Reply to reviewers' comments

Reviewer 1 (RC1)

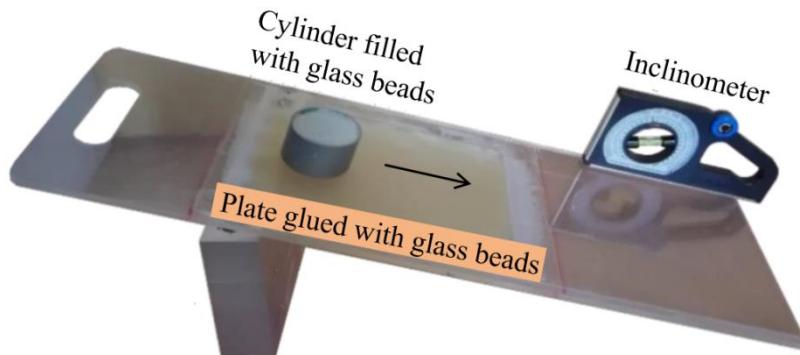
C5: Line 94. Why a 5 degree slope is chosen for deposition of debris flow? Does this represent the prototype condition?

R5: Yes. The buildings and infrastructure are mainly located on the deposition area of debris flow catchment, and 5 degree is a typical slope for the deposition area. We have made clarification accordingly.
